WIRELESS SET, CANADIAN, NO 19, MK 3

TECHNICAL HANDBOOK - MODIFICATION INSTRUCTION

Removal of B-set facility

Fig 1 - Underside view of valveholders

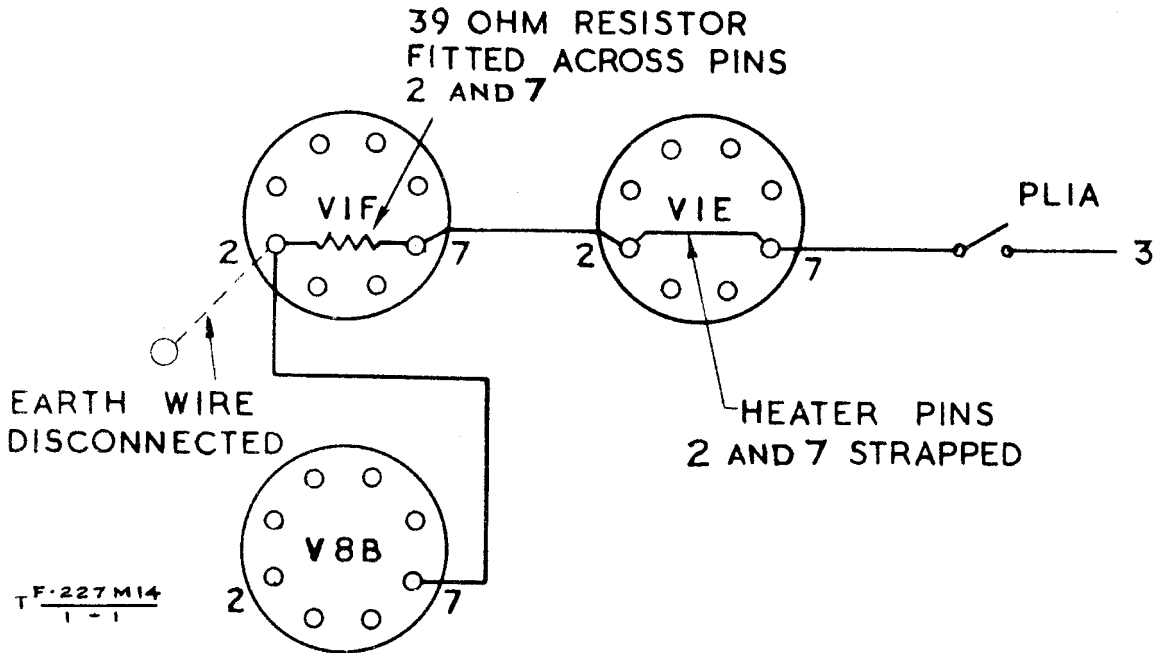
6. (a) Withdraw the set from its case and remove the baseplate.
- (b) Identify the underside of valveholders V1E, V1F, V8B, (Tels F 224, Fig 7 refers).
- (c) Disconnect the wire from pin 2 of valveholder V1F to earth. Disconnect the linking wires between pin 7 of V1D and pin 7 of V1F and also those between pin 2 of V1E and pin 7 of V8B.

- (d) Connect a wire between pin 2 of valveholder V1F and pin 7 of valveholder V8B.
- (e) Solder the 390 resistor between pins 2 and 7 of valveholder V1F.

- (f) Solder a wire between pins 2 and 7 of valveholder V1E.
- (g) Remove the screening cans from valves V1D and V1E and remove valves V7A, V1D, V1E and V8A from the equipment. The grid leads of valves V1D and V1E will be neatly removed; the former by disconnecting the lead at a point as close as possible to the junction of capacitor C15G and resistor R6G, and the latter at the B-set relay, top layer terminal No 2 (Tels F 224 Table 25 refers). Remove the retainer of valve V8A where fitted.
